REPLACEMENT OF HUNT ROAD AT MONO POND
COLUMBIA, CT
ADDENDUM NO. 1
July 18, 2023

1. Sign in sheet for optional pre-bid meeting held on June 29, 2023
(1 page)
2. Responses to questions and additional information discussed at the pre-bid meeting.
(2 pages)
3. Revised Plan Sheets 3 and 7.

PROJECT 3169-14 DATE 06/12/23 SHEET NO. 3 OF 9

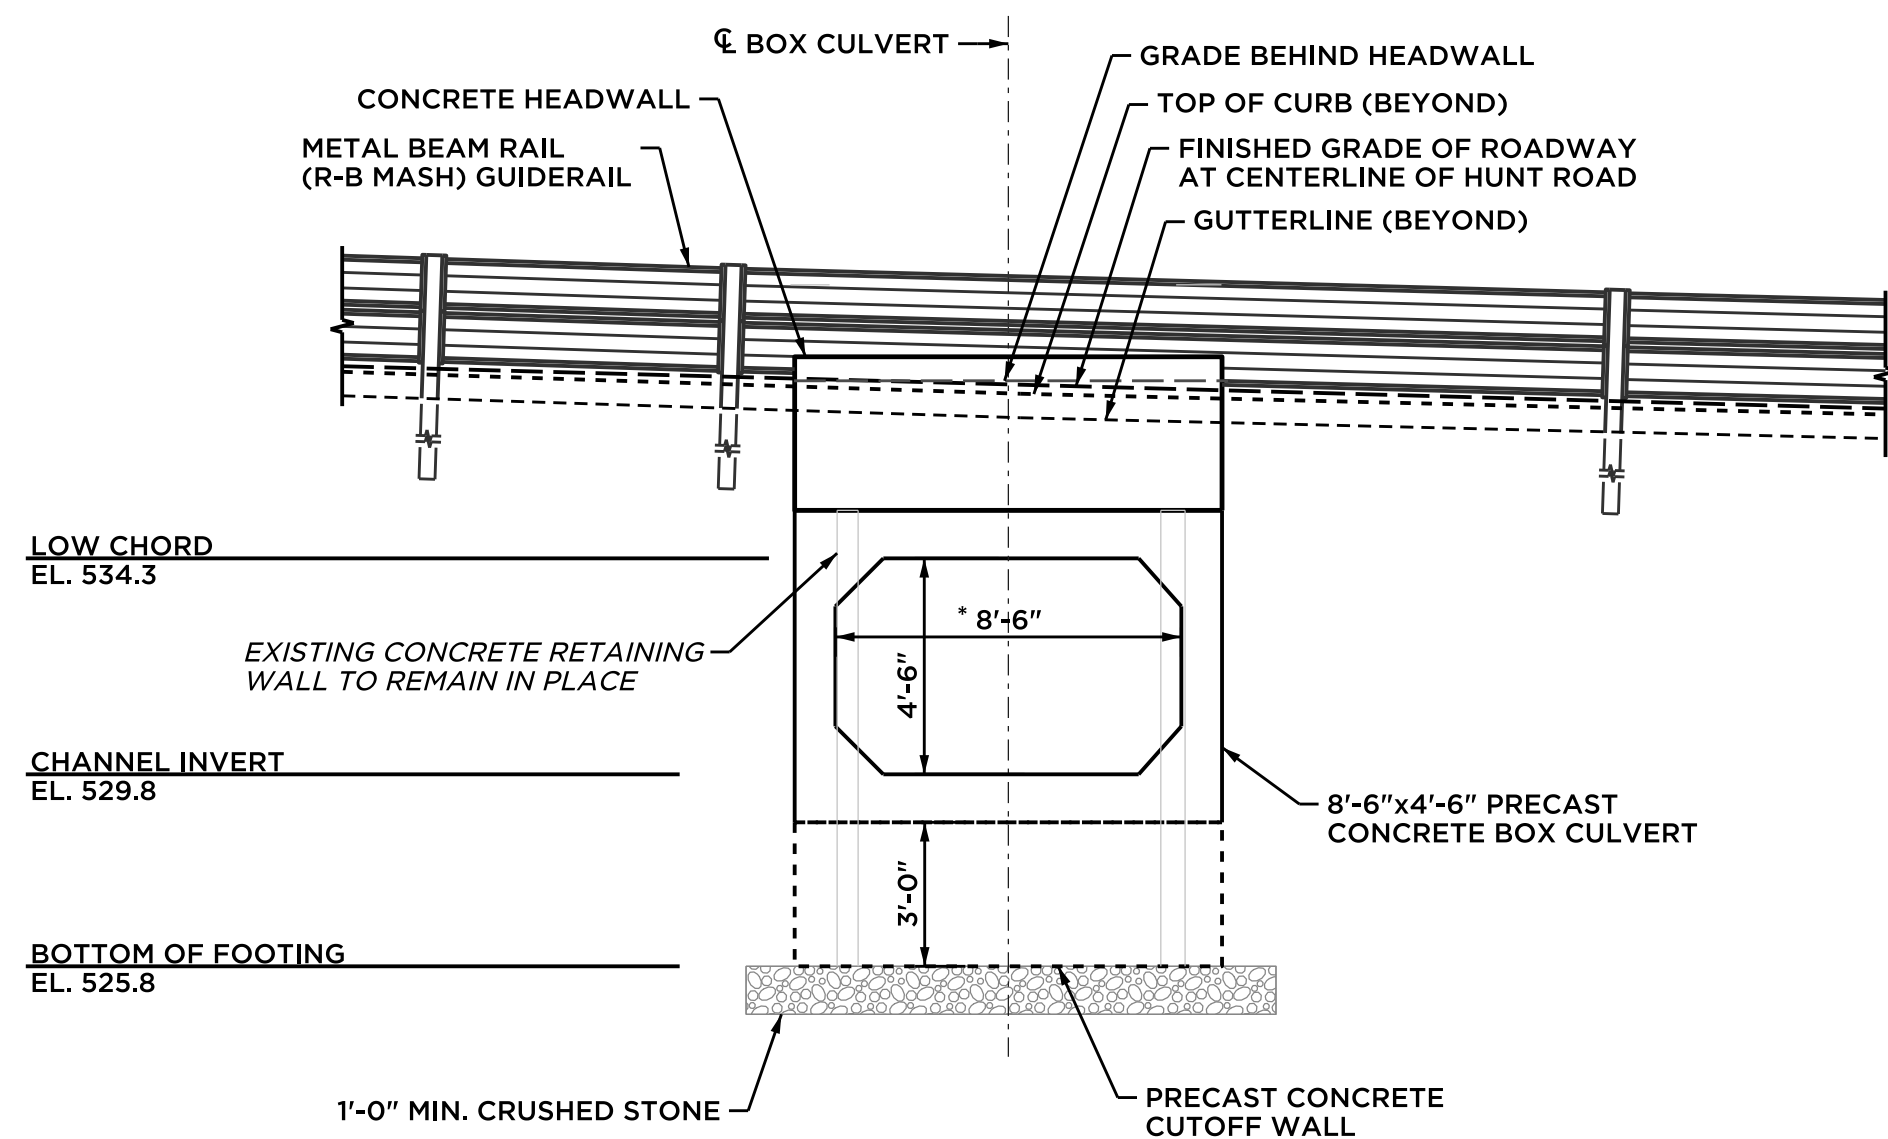
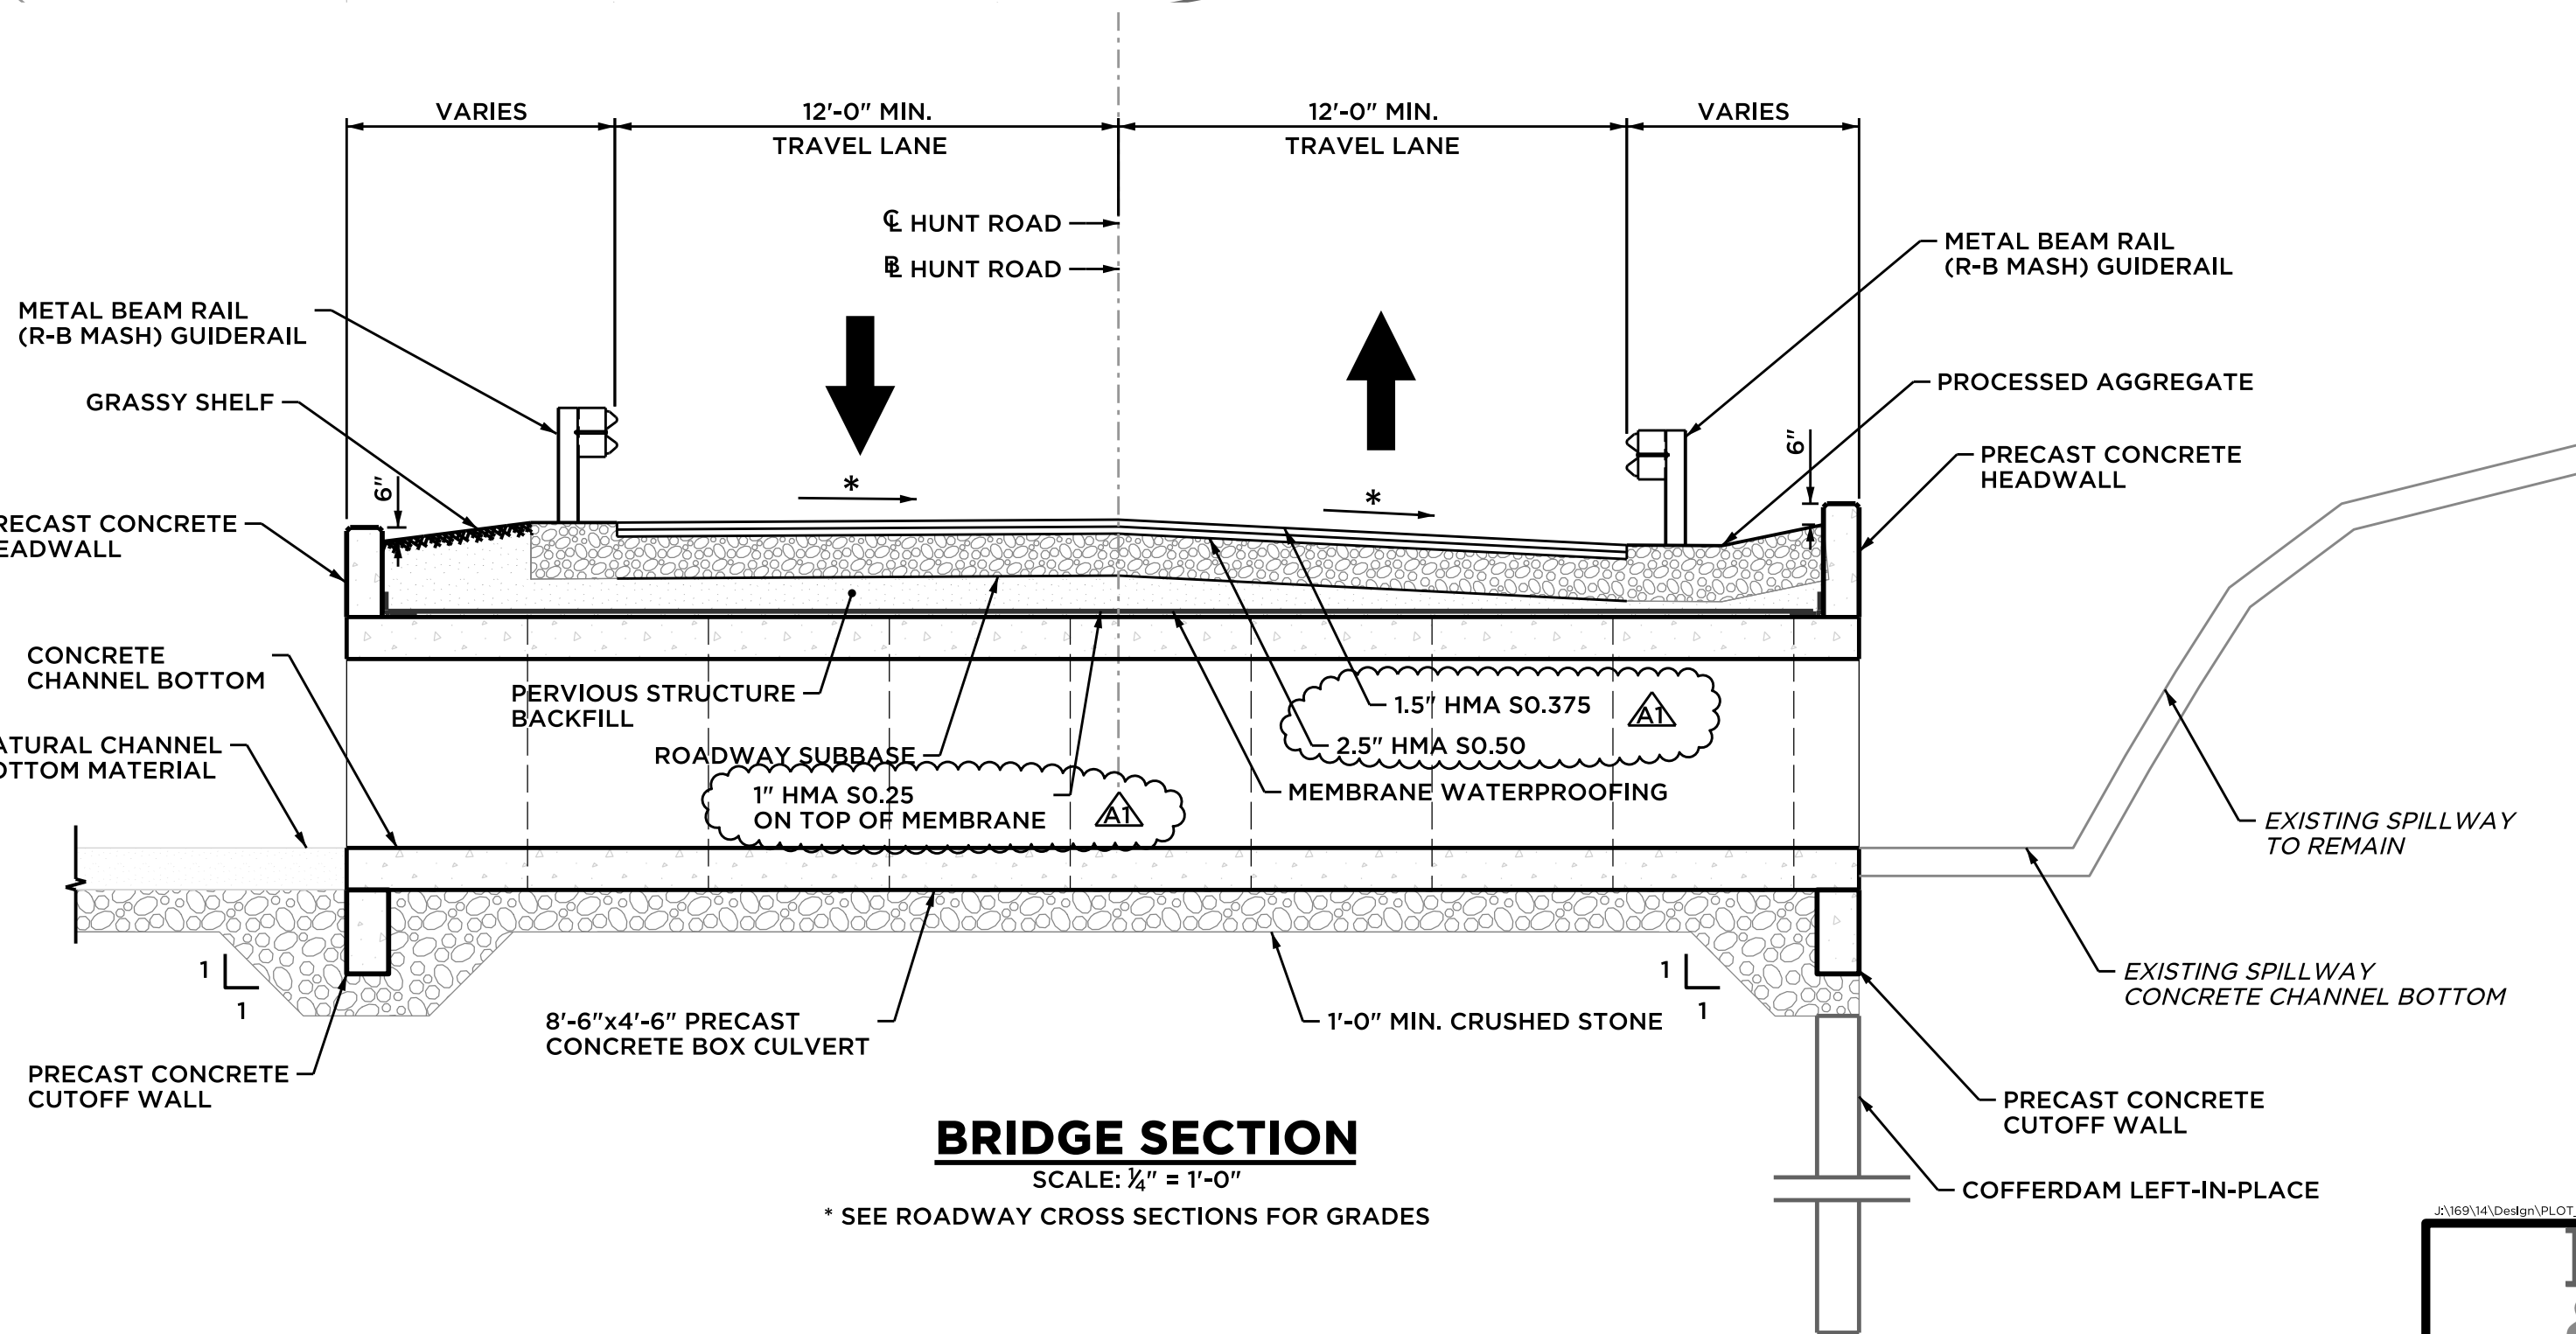
Question – The asphalt sections shown on sheets 2 and 3 do not match. What is the intent?

Response – The proposed pavement section is as shown on sheet 2. Sheet 3 has been revised.
